ATTACHMENT 1

PROPOSED CHANGES TO DPR-25

TECHNICAL SPECIFICATIONS

Affected Pages: viii  
3/4.1-8/Table 4.1.1  
3/4.1-9/Table 4.1.1 Notes  
3/4.1-10/Table 4.1.2 and Notes  
3/4.1-19/Bases  
3/4.1-20/Bases  
3/4.2-19/Table 4.2.1  
3/4.2-20/Table 4.2.1  
3/4.2-21/Table 4.2.1 Notes  
3/4.2-36/Bases  
3/4.2-37/Bases  
3/4.2-38/Figure 4.2.2

Figure 4.2.2

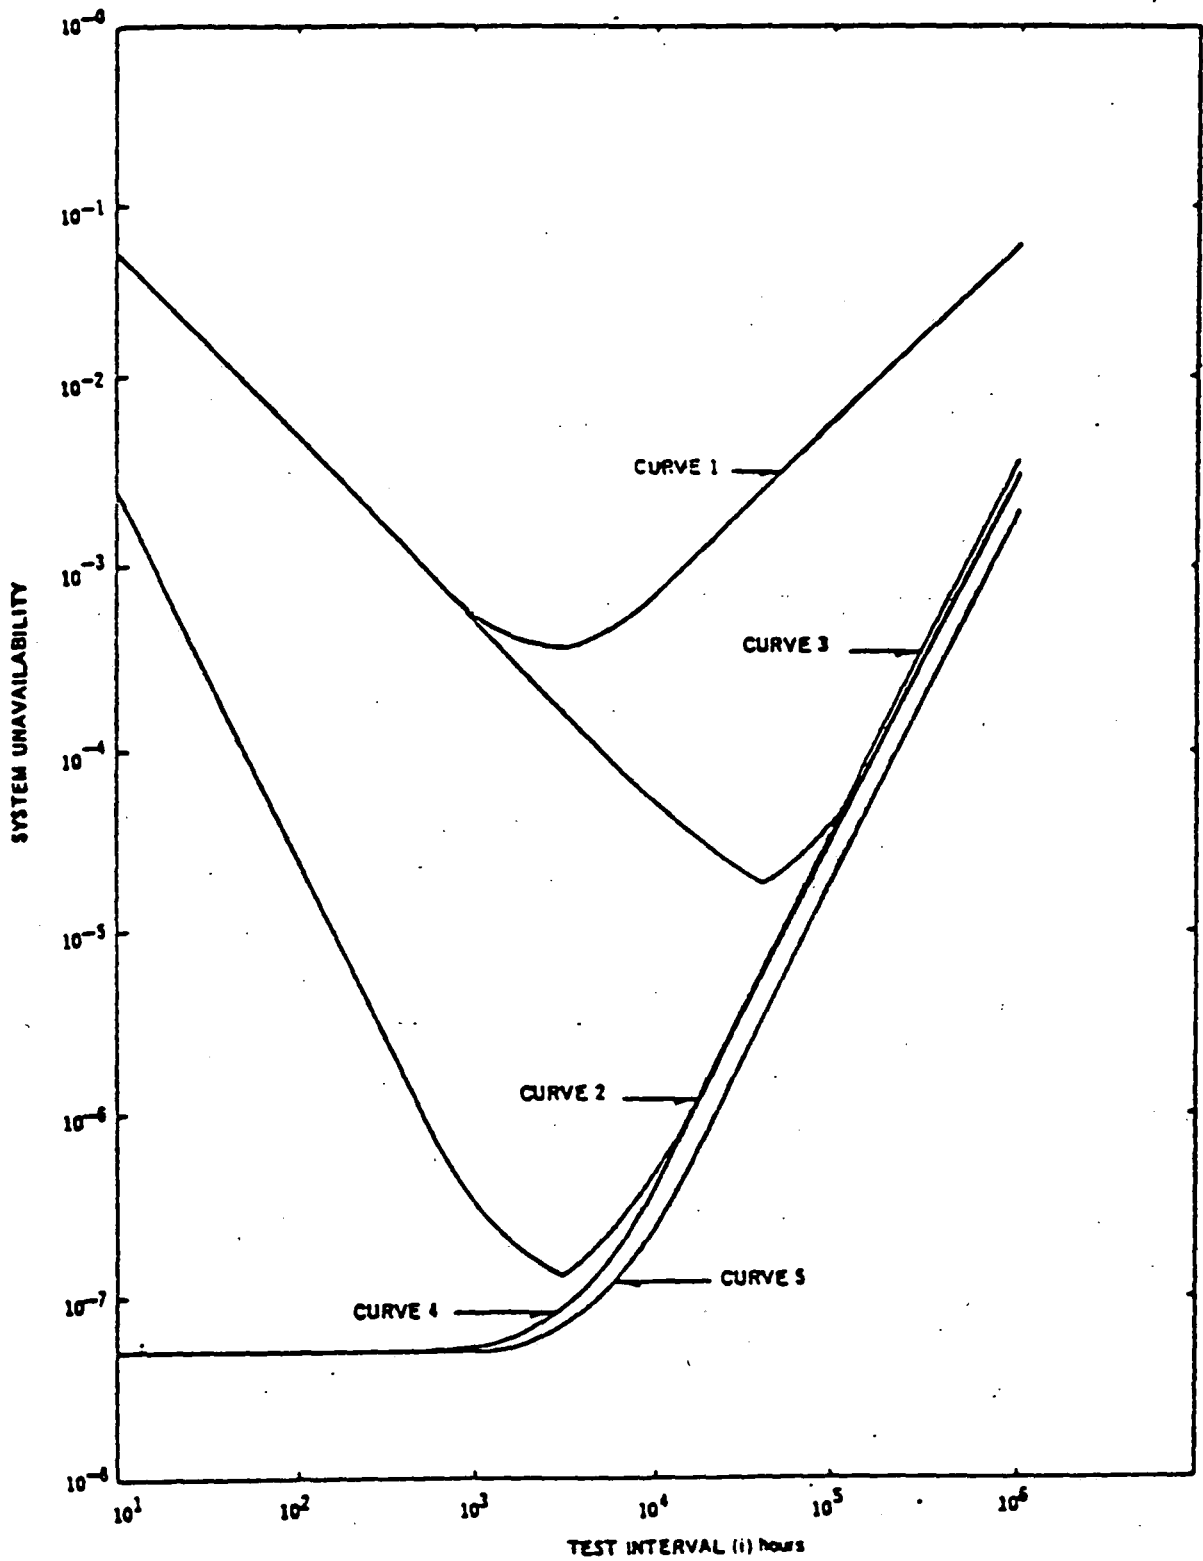
A more usual case is that the testing is not done independently. If both channels are bypassed and tested at the same time, the result is shown in Curve No. 3. Note that the minimum occurs at about 40,000 hours, much longer than for cases 1 and 2. Also, the minimum is not nearly as low as Case 2 which indicates that this method of testing does not take full advantage of the redundant channel. Bypassing both channels for simultaneous testing should be avoided.

The most likely case would be to stipulate that one channel be bypassed tested and restored, and then immediately following, the second channel be bypassed, tested, and restored. This is shown by Curve No. 4. Note that there is no true minimum. The curve does have a definite knee and very little reduction in system unavailability is achieved by testing at a shorter interval than computed by the equation for a single channel.

The best test procedure of all those examined is to perfectly stagger the tests. That is, if the test interval is four months, test one or the other channel every two months. This is shown in Curve No. 5. The difference between Cases 4 and 5 is negligible. There may be other arguments, however, that more strongly support the perfectly staggered tests, including reductions in human error.

1. A 1 out of n system may be treated the same as a single channel in terms of choosing a test interval; and
2. More than one channel should not be bypassed for testing at any one time.
